Landscape Review Committee
ZOOM Online Meeting
Wednesday, April 21, 2021 - 12:00 PM

DATE: April 21, 2021
TO: Landscape Review Committee Members
FROM: Jamie Fleckenstein, Associate Planner
SUBJECT: Agenda Item 4A – Harmony Fields Addition Street Tree Improvement Plan (L 7-21)

DATE: April 21, 2021
TO: Landscape Review Committee Members
FROM: Jamie Fleckenstein, Associate Planner
SUBJECT: Agenda Item 4B - Street Tree Removal Application (L 8-21)

Figure 2: Site Plan

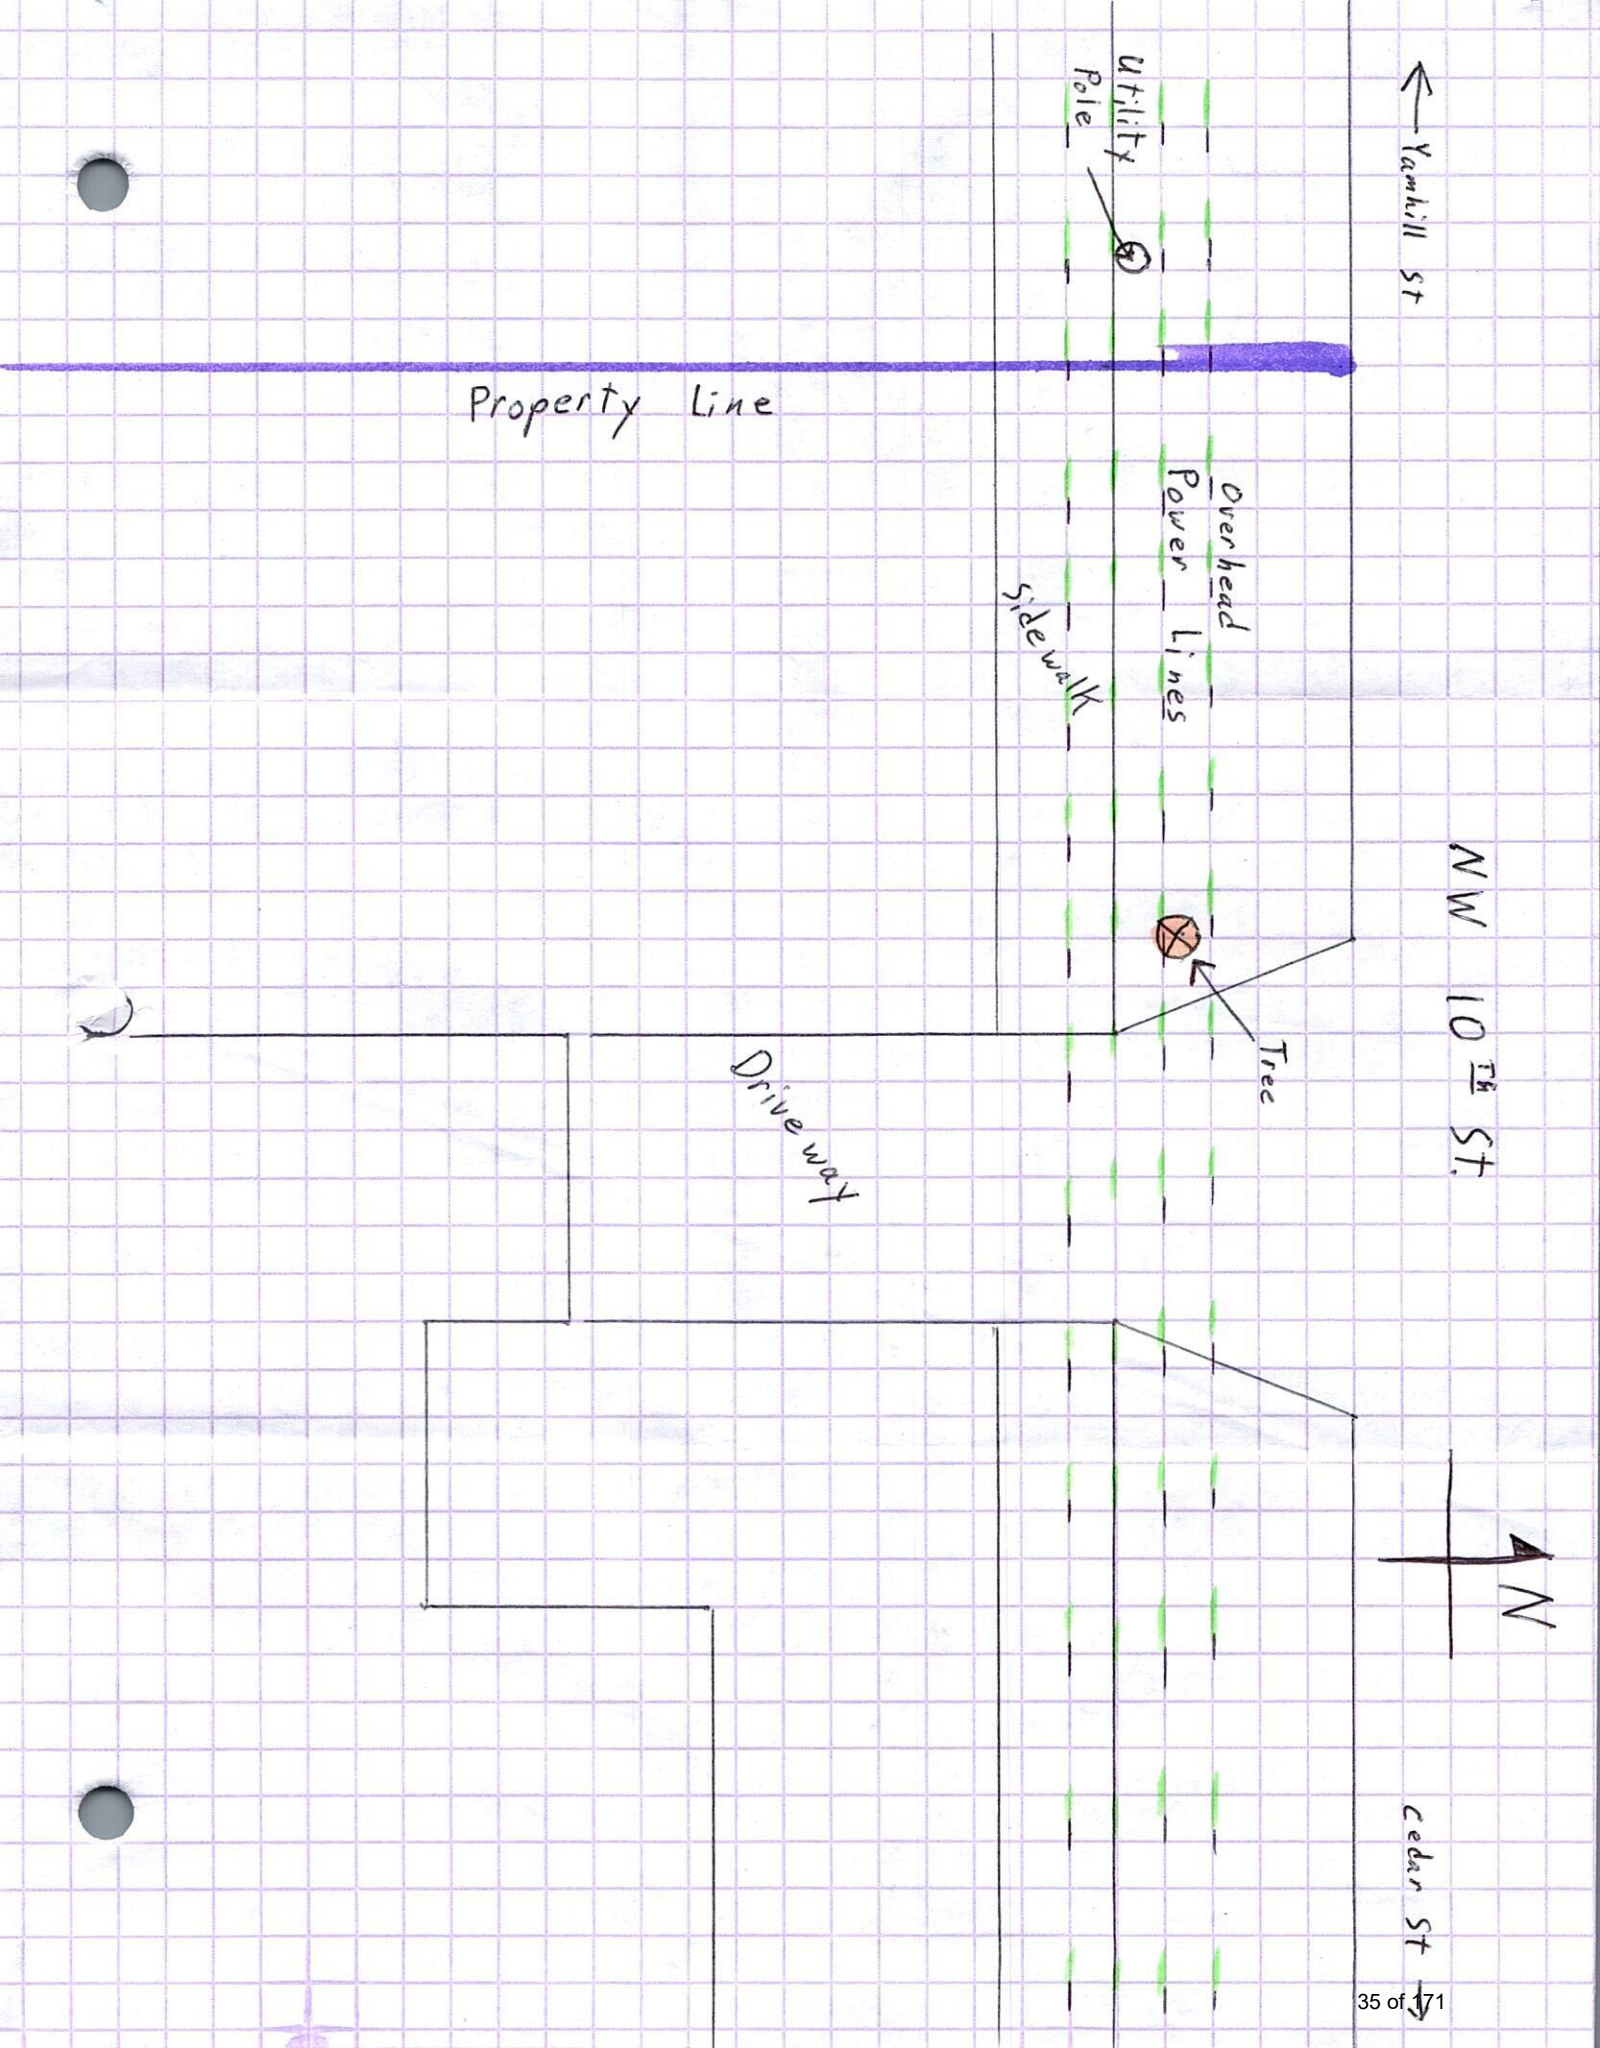
A condition of approval is included to require one (1) replacement street tree selected from the Recommended Small Tree Species from the McMinnville Street Tree List appropriate for planting under wires. Staff recommends the replacement tree be located east of the existing driveway.

2 PLANTING PLAN WEST

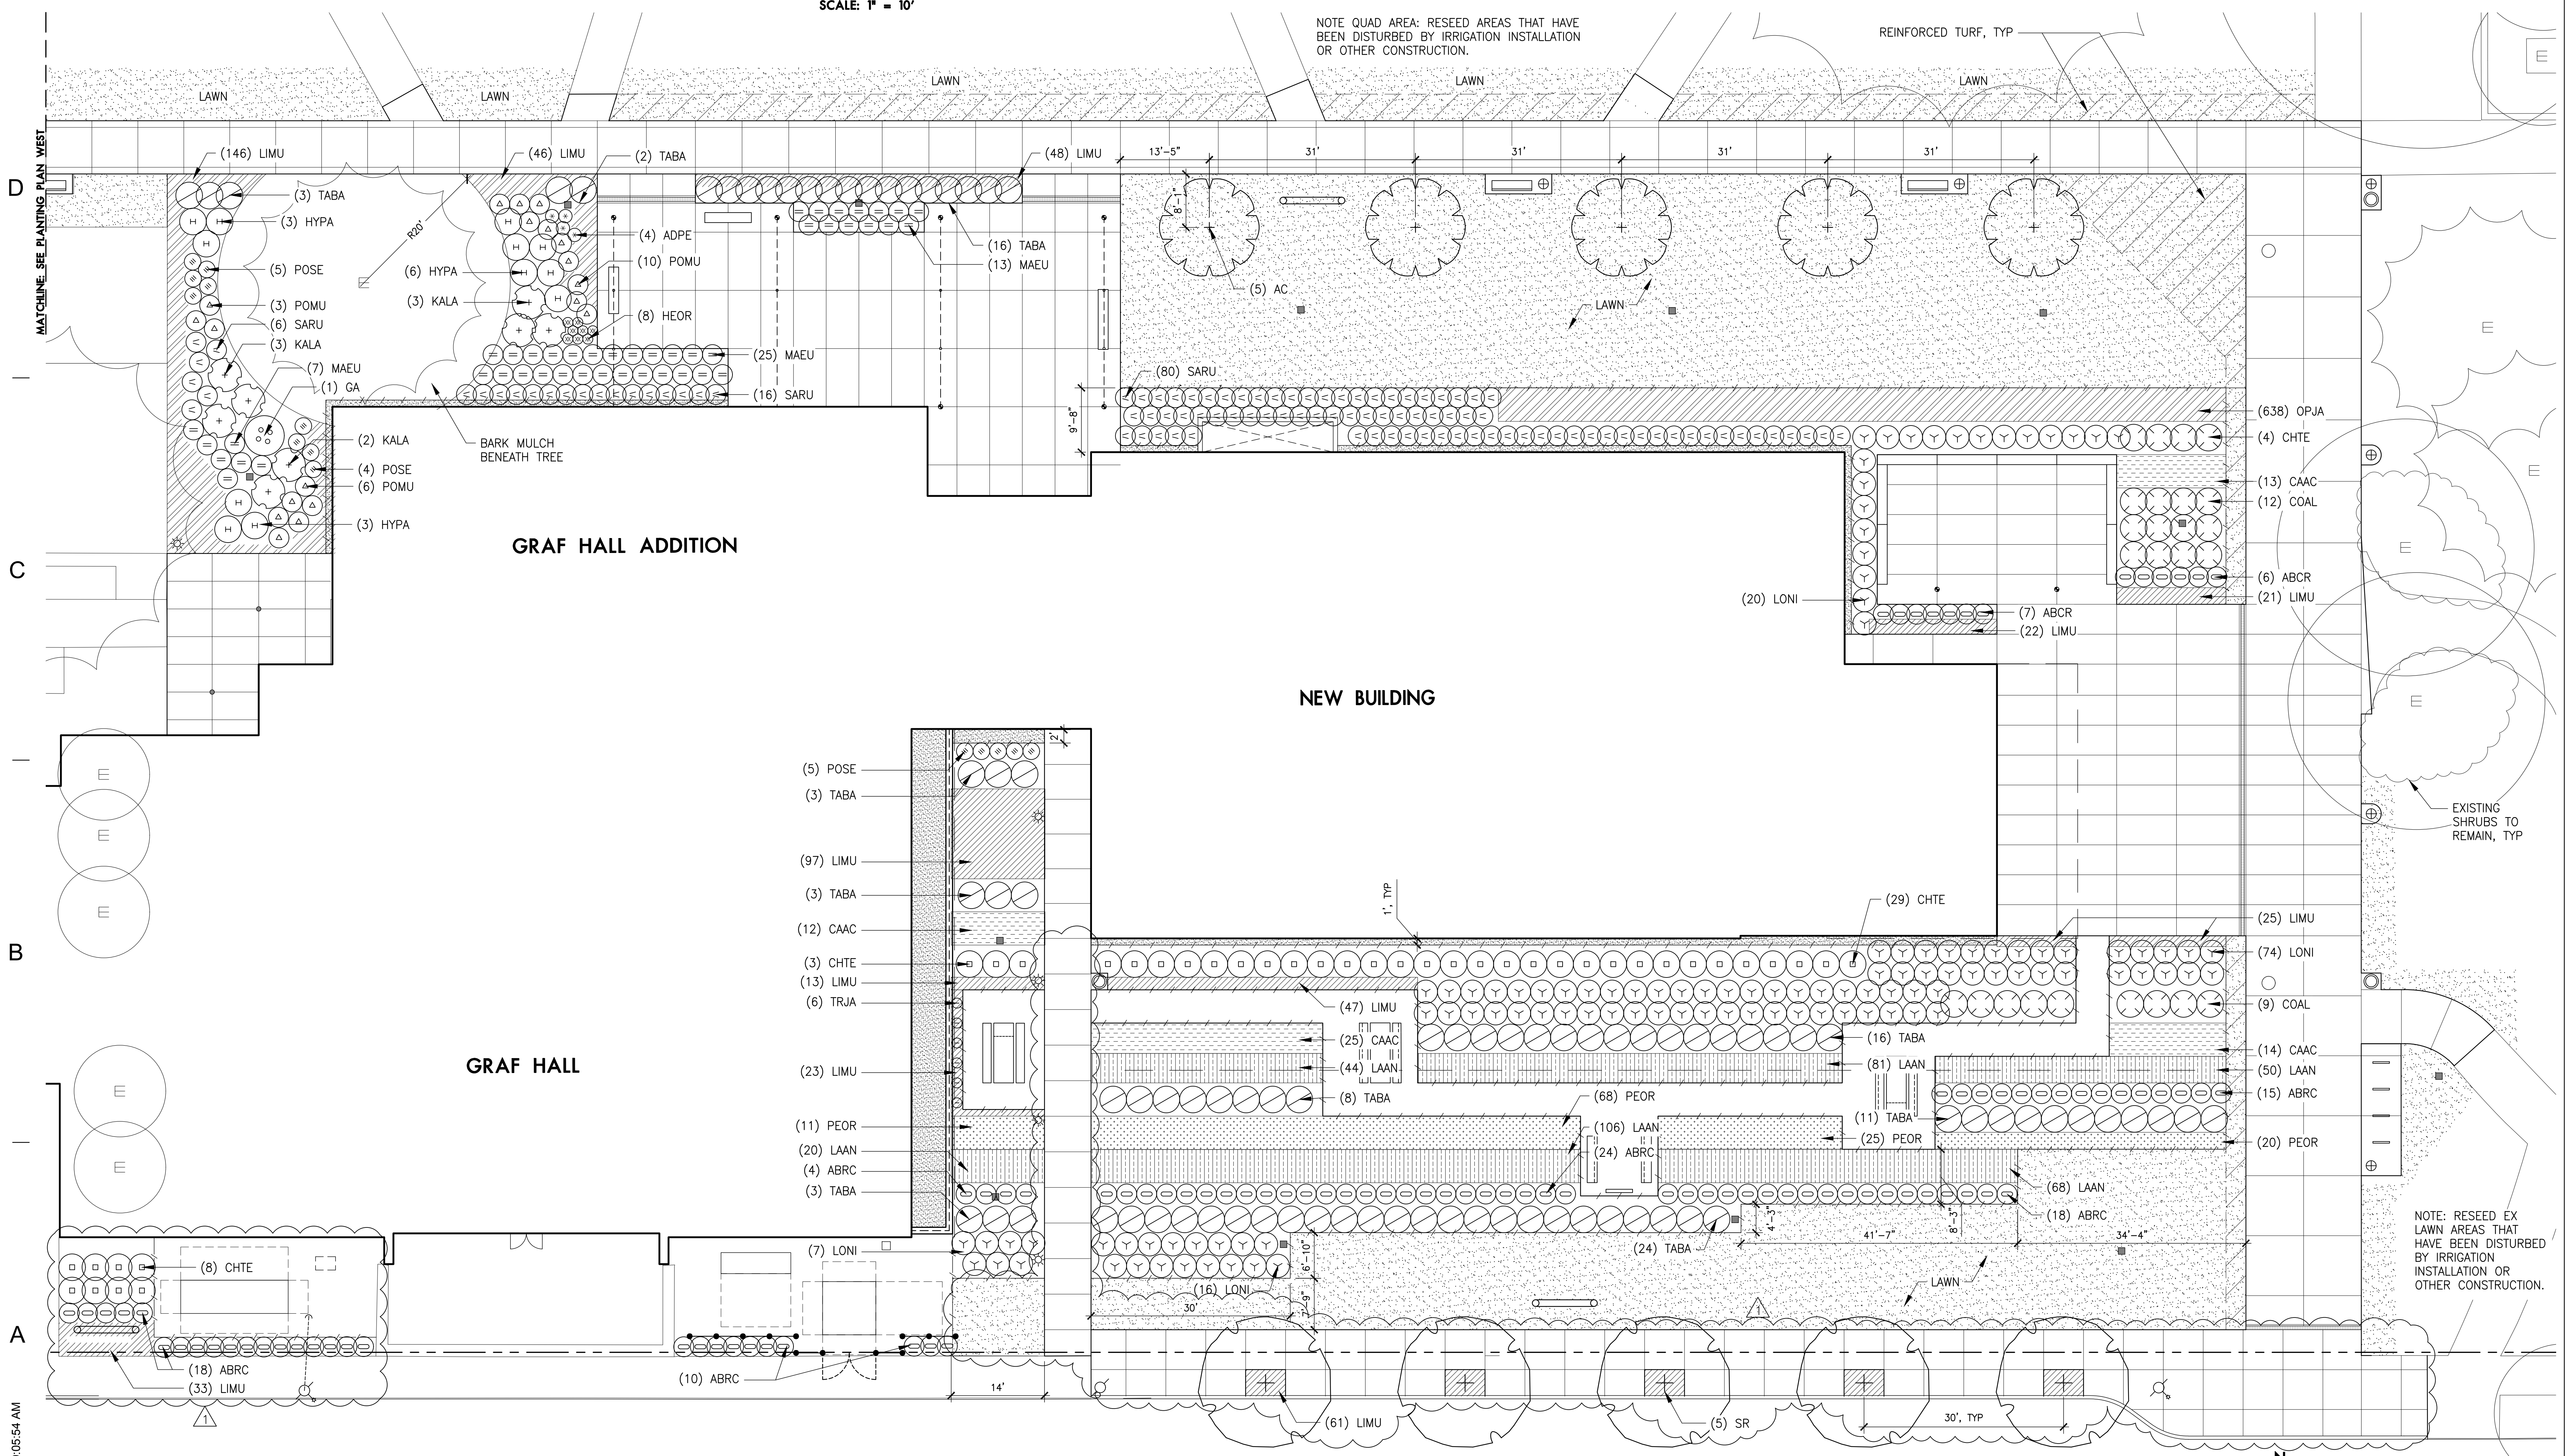
FINDING: SATISFIED. The applicant has submitted detailed landscape and irrigation plans for review and approval of the McMinnville Landscape Review Committee. All proposed trees exceed the minimum two-inch caliper specification.
